Final Product/Process Change Notification

Document #:FPCN23658ZE

Title of Change:	Wafer fab transfer to onsemi Gresham, Oregon USA from onsemi Fab2, Oudenaarde, Belgium related to Fab2 sale
Proposed Changed Material First Ship Date:	22 Apr 2022 or earlier if approved by customer
Current Material Last Order Date:	31 Jan 2022/PD24321Z <i>Orders received after the Current Material Last Order Date expiration are to be considered as orders for new changed material as described in this PCN. Orders for current (unchanged) material after this date will be per mutual agreement and current material inventory availability.</i>
Current Material Last Delivery Date:	21 Apr 2022 <i>The Current Material Last Delivery Date may be subject to change based on build and depletion of the current (unchanged) material inventory</i>
Product Category:	Active components – Integrated circuits
Contact information:	Contact your local onsemi Sales Office or Alicia.Tuckett@onsemi.com
PCN Samples Contact:	Contact your local onsemi Sales Office to place sample order or < PCN.samples@onsemi.com >. Sample requests are to be submitted no later than 45 days after publication of this change notification. Samples deliv

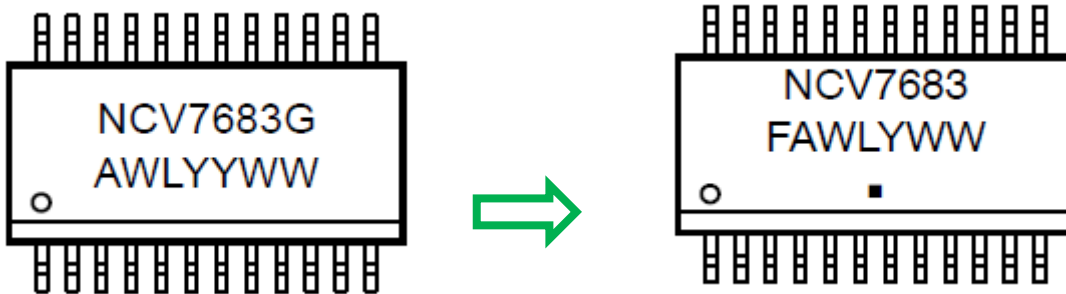
Wafer fab transfer to onsemi Gresham, Oregon USA from onsemi Fab2, Oudenaarde, Belgium related to Fab2 sale. We are moving from non roughened to roughened PPF leadframe and updated the Case Outline Drawing. Part marking and datasheet will also be updated.

Before Change Description	After Change Description
Fab Site transfer	onsemi Fab2, Oudenaarde, Belgium 6inch	onsemi Gresham, Oregon USA 8inch
LeadFrame	N51512E706 (non roughened)	N51512E810 (roughened)
Case Outline Drawing	Case outline 940AP	Case outline 940AQ
Datasheet Updates	Current Datasheet (Rev.3)	Updated Datasheet Typo corrections and changes listed in this table. (Rev.4)
Part Marking	Without Fab Indicator	With Fab Indicator

Figure 2. Pinout Diagram

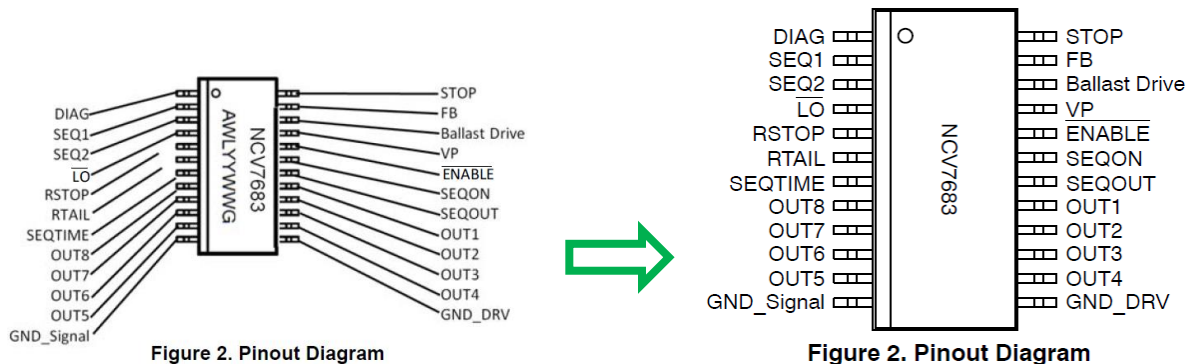
Pinout Diagram

Better graphical styling is reflected to the pinout diagram.

Figure 3. Application Diagram with External FET Ballast Transistor

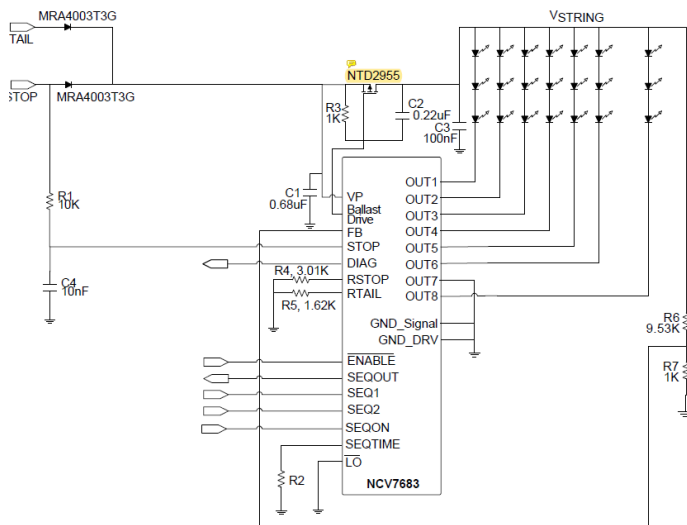
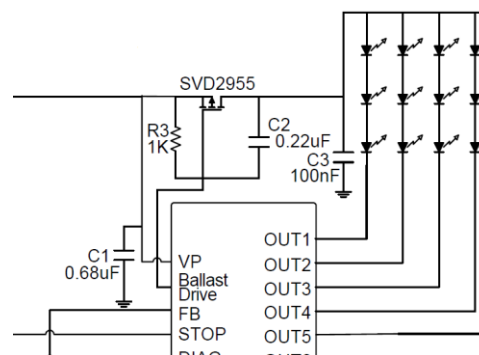
Updating an External FET Ballast Transistor

The NTD2955 component is obsolete, the equivalent part SVD2955 is replaced in whole datasheet (Text + drawings)
The SVD2955 has the same performance as NTD2955.
